CHASSIS FRAME

CATEGORY 3A MODIFICATION.

WELDED FRAME STIFFENERS.

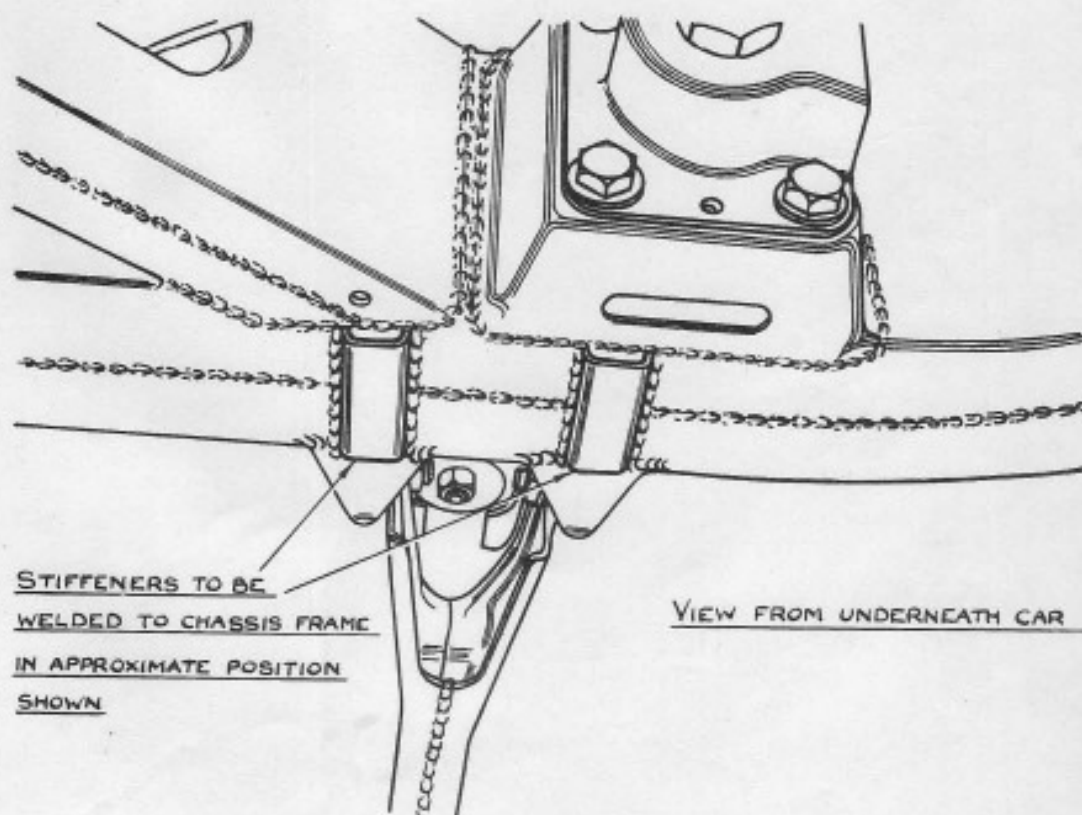
On certain cars it may be found that when raising the car with the car jack provided, the jacking spigot "springs" relative to the frame, and it may even be possible in extreme cases for this to damage the frame.

To prevent any "springing" at the jacking point and to overcome any possibility of damage to the frame, stiffening pieces are to be electrically welded to the underside of the frame adjacent to the jacking points as illustrated.

In the unlikely event of damage to the frame, which will be evident in the form of a split in the welding along the underside of the frame, the frame is to be welded electrically. It is neither desirable nor practicable for these components to be gas welded.

<u>Part No.</u>	<u>No.Off.</u>
Chassis Frame Stiffener	UR.3305.	4.

MODIFICATION TO THE FUEL TANK MOUNTING STRAP
INTERMEDIATE BRACKET.

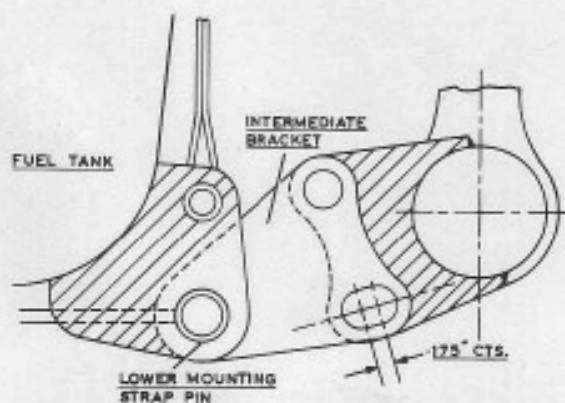
It may be necessary on certain cars to lower the rear of the fuel tank so that the wiring loom fitted to the undersurface of the boot floor cannot be chafed between the top of the fuel tank and the undersurface of the boot floor.

Raise the rear right hand road wheel and remove it to inspect whether sufficient clearance exists between the upper surface of the fuel tank and the undersurface of the boot floor. If the wiring loom shows signs of being chafed it must be replaced, or if the clearance is inadequate, the four rear mounting intermediate brackets are to be modified.

Support the fuel tank in such a manner that it cannot be damaged by its own weight and so that the load is removed from the mounting straps. Disconnect the mounting straps by removing the two lower-most strap pins, one each side, and withdrawing the lower straps from the strap pins by removing the two adjusting nuts. Remove the intermediate bracket securing nuts and bolts and elongate the lower bolt holes as indicated.

Replace the brackets and strap pins leaving the intermediate bracket fixing bolts loose until the fuel tank mounting shoes have been positioned to allow the tank to assume the correct clearance from the undersurface of the boot floor. Inspect to ensure that the fuel tank does not foul elsewhere. It will be necessary to relieve the fuel tank support to facilitate this operation, but leaving it close in position for safety.

Refit the lower mounting straps in the strap pins and tighten the intermediate bracket fixing bolts, finally inspect to ensure that the clearance has not altered afterwards.
